#### APPEAL SUMMARY

<b>Appeal ID:</b> 24527	<b>Project Address:</b> 5460 N Interstate Ave
<b>Hearing Date:</b> 1/20/21	<b>Appellant Name:</b> Joshua Scott
<b>Case No.:</b> B-005	<b>Appellant Phone:</b> 2067551290
<b>Appeal Type:</b> Building	<b>Plans Examiner/Inspector:</b> John Cooley
<b>Project Type:</b> commercial	<b>Stories:</b> 6 <b>Occupancy:</b> R2 <b>Construction Type:</b> III-A over 1-A
<b>Building/Business Name:</b>	<b>Fire Sprinklers:</b> Yes -
<b>Appeal Involves:</b> Erection of a new structure	<b>LUR or Permit Application No.:</b> 20-146519-CO
<b>Plan Submitted Option:</b> pdf [File 1] [File 2] [File 3] [File 4]	<b>Proposed use:</b> Multifamily Residential/Commercial

### Floor Plan of Lobby Space - 5460 North Interstate

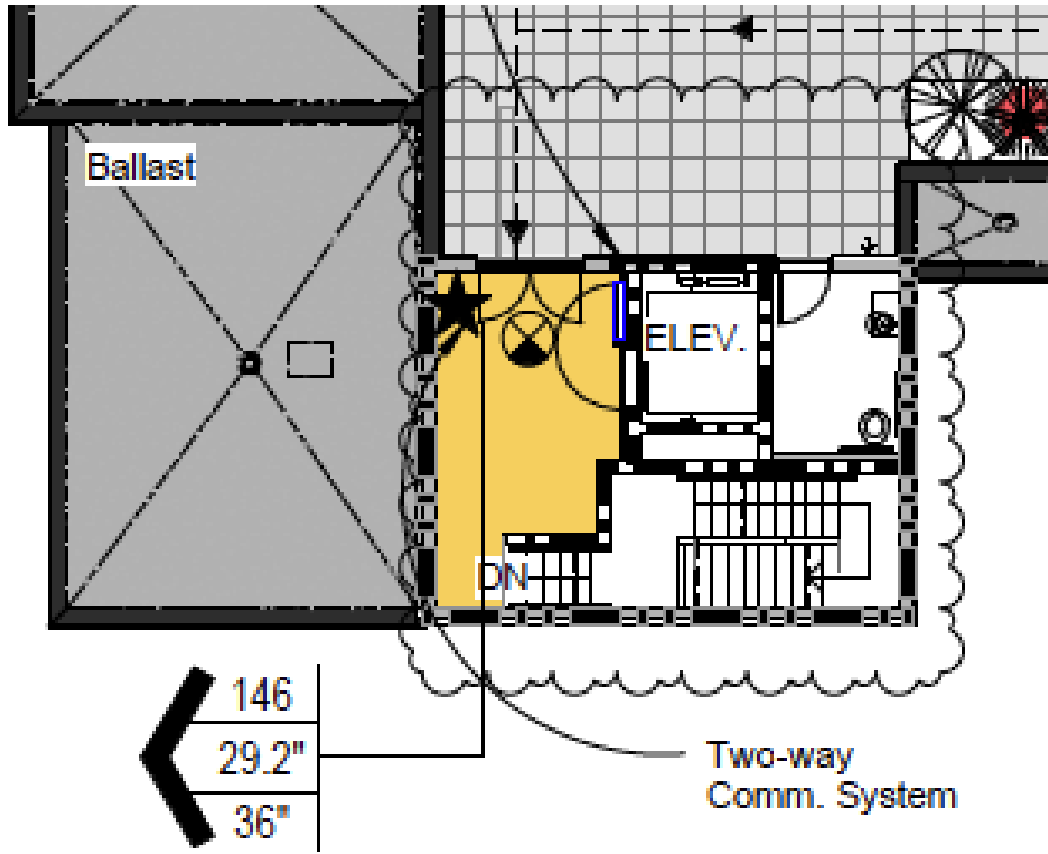
<b>Code Section</b>	OSSC 2902.2.2
<b>Requires</b>	Separate facilities shall not be required in structures or tenant spaces with a total occupant load, including both employees and customers, of 30 or fewer. One single-user toilet room shall be permitted.
<b>Code Modification or Alternate Requested</b>	It is requested that separate facilities not be required in the lobby of this multifamily building with an occupant load of 48.
<b>Proposed Design</b>	A single user toilet facility has been provided to serve this area.
<b>Reason for alternative</b>	The lobby of this building serves a population that all have access to individual bathroom facilities. The assembly opportunities within the lobby are minimal and will mostly involve greeting potential residents for tours, and resident gathering while awaiting deliveries, ride share, transit, etc. The single-user toilet facility provided is primarily for use by the leasing manager and as an added convenience for residents who may be congregated in the lobby space.

The lobby of this building serves a population that all have access to individual bathroom facilities. The assembly opportunities within the lobby are minimal and will mostly involve greeting potential residents for tours, and resident gathering while awaiting deliveries, ride share, transit, etc. The single-user toilet facility provided is primarily for use by the leasing manager and as an added convenience for residents who may be congregated in the lobby space.

- 1. Reduction in minimum required number of plumbing fixtures: Granted as proposed.**
- 2. Mechanical penthouse with toilet room for use by occupants of rooftop assembly space: Granted as proposed.**
- 3. Use of combustibile framing within Type 1A construction: Denied. Proposal does not provide equivalent Life Safety protection.**
- 4. Type 13 water curtain sprinkler protection at non-fire rated openings in exterior walls of egress court less than 10' in width: Granted provided windows are non-operable, and sprinklers are spaced not more than 6 feet apart and placed a minimum of 6 inches and a maximum of 12 inches from the opening(s) and a maximum of 12 inches below the ceiling. Sprinklers are to be installed on the occupied side of the openings. A separate permit from the Fire Marshal's Office is required.**

Roof Level Floor Plan - 5460 North Interstate

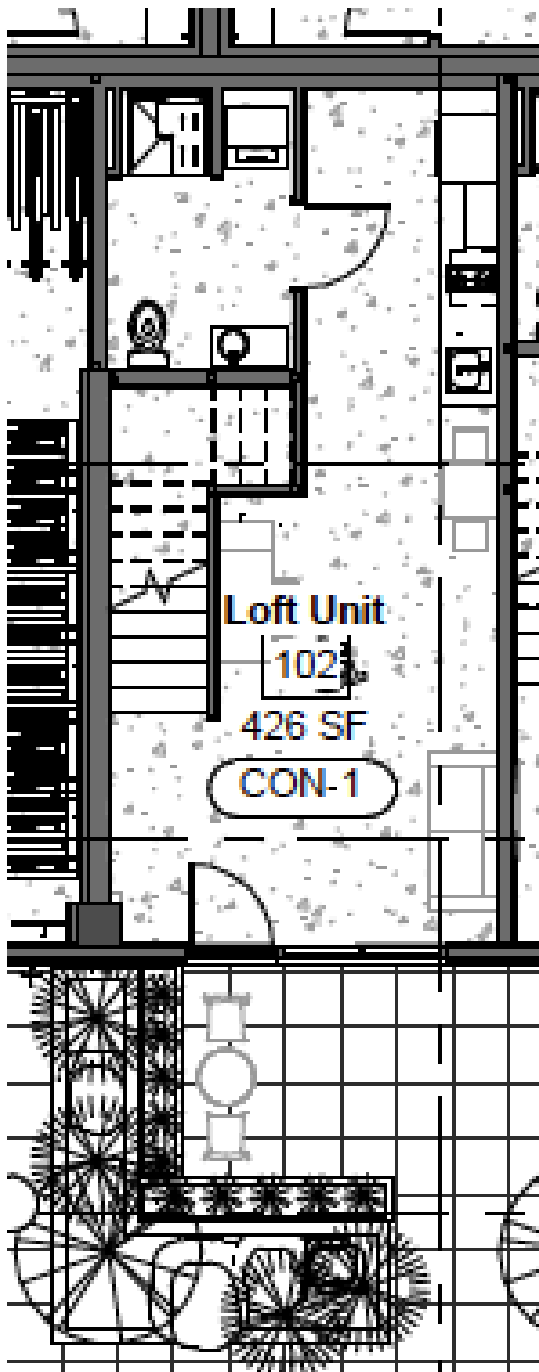
<b>Code Section</b>	1510.2.2, Table 504.4
<b>Requires</b>	Penthouses shall not be used for purposes other than the shelter of mechanical or electrical equipment, tanks, elevators and related machinery, or vertical shaft openings in the roof assembly.  Table 504.4 limits the number of stories of this building to 5 over the podium.

**Code Modification or Alternate Requested** Allow the limited circulation and single use toilet facility to be included in the area of the floor below as part of the penthouse structure.

**Proposed Design** Access to the rooftop amenity has been provided by elevator and stairway. Both of these features are contained within penthouse structures. A single-user toilet facility was added to the rooftop for the convenience and to provide additional toilet facilities (beyond each of the residents private bathroom facilities) for the assembly occupancy created at the rooftop.

An additional story is not available to this construction type. The toilet facility can be included within the penthouse structure easily and will provide a facility for the amenity space without generating additional occupant load. No habitable space is being created to provide the toilet facility. If considered part of the penthouse function, it will be included within the area of the floor below and could be allowed without establishing an additional story to the building.

Floor plan of unit with sleeping loft

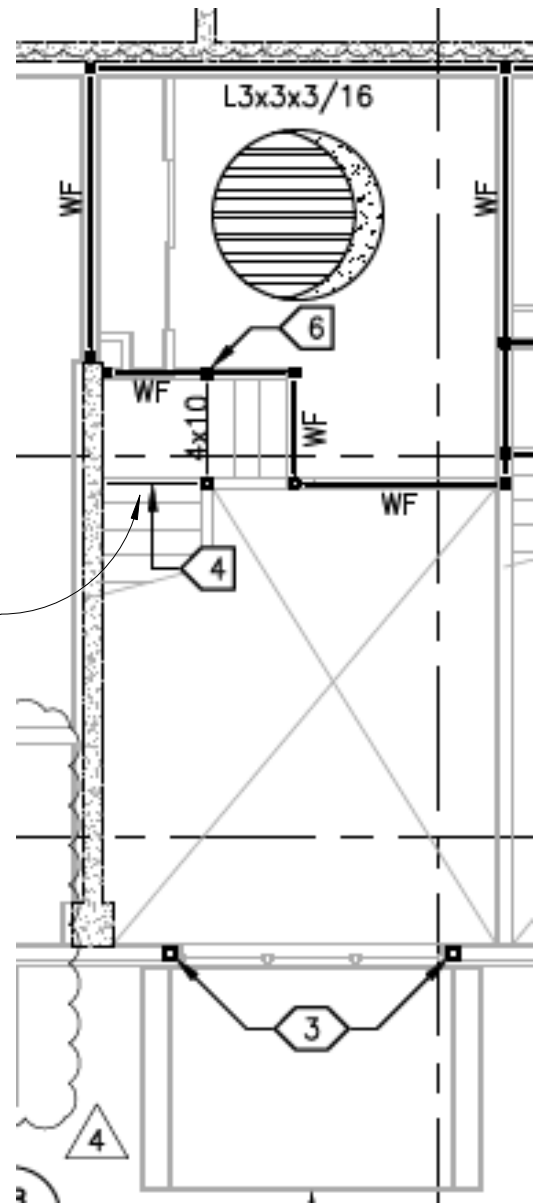
**Code Modification or Alternate Requested** It is requested that the limited amount of framing within the small stairway leading to the mezzanine within the dwelling units be allowed to be constructed of Fire-retardant-treated wood.

**Proposed Design** Fire retardant treated lumber, covered with type x gypsum board is proposed for all framing and supports for the stairway.

All framing in stairway from mezzanine sleeping area to be Fire Retardant Treated wood.

Framing Plan of mezzanine loft

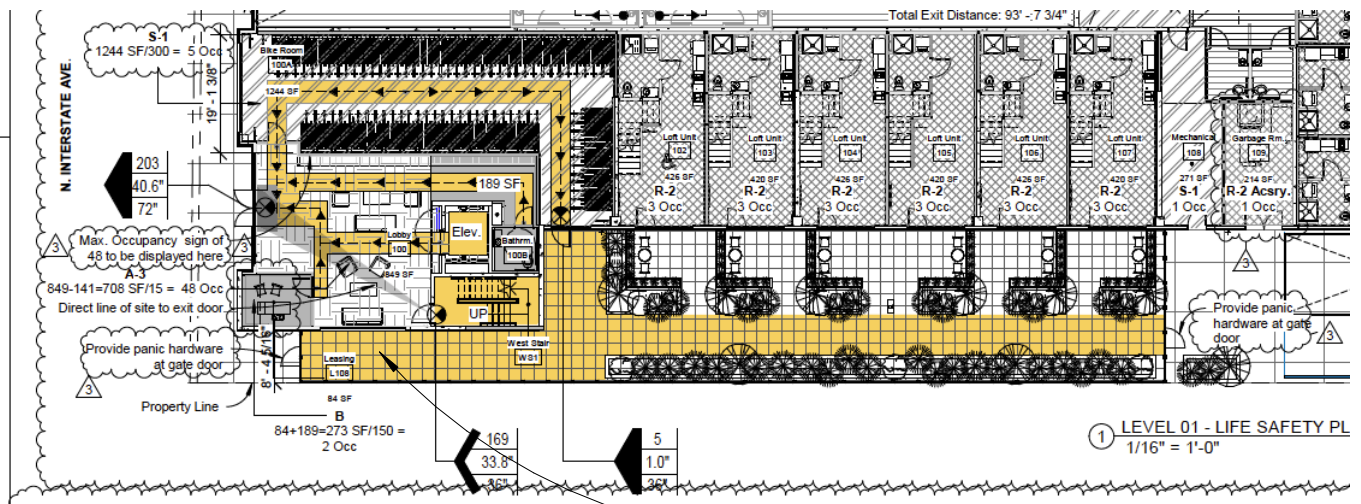
**Reason for alternative** Noncombustible construction for the stairways is difficult to accomplish. The stairway serves an occupant load of 2, and exists entirely within an individual dwelling unit that is fully sprinklered. FRT framing covered with Type X gypsum wallboard will provide an essentially noncombustible condition at this area. The code is unclear as to how a stairway utilized within a dwelling unit to a mezzanine is to be categorized.
